**Re: Hydro Hawkesbury Inc. (Hydro Hawkesbury)  
2018 Distribution Rate Application  
OEB Staff Interrogatories  
OEB File No.: EB-2017-0048**

**OEB Staff Interrogatories**  
**2018 Cost of Service Rate Application**  
**Hydro Hawkesbury Inc. (Hydro Hawkesbury)**  
**EB-2017-0048**  
**October 18, 2017**

The graphs below show Hydro Hawkesbury’s system reliability metrics as included on page 26 of the Business Plan filed with its application:

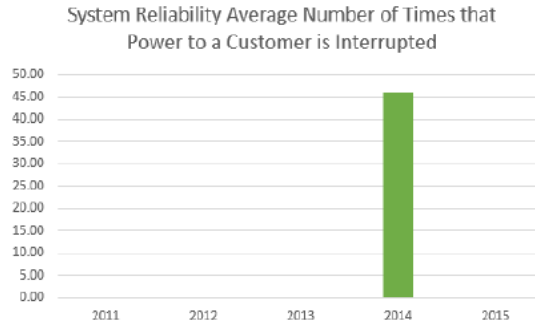
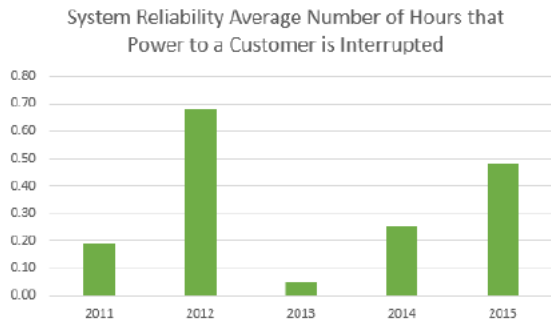
The table below shows Hydro Hawkesbury’s system reliability metrics as available on the OEB’s website (using its build custom reports feature):
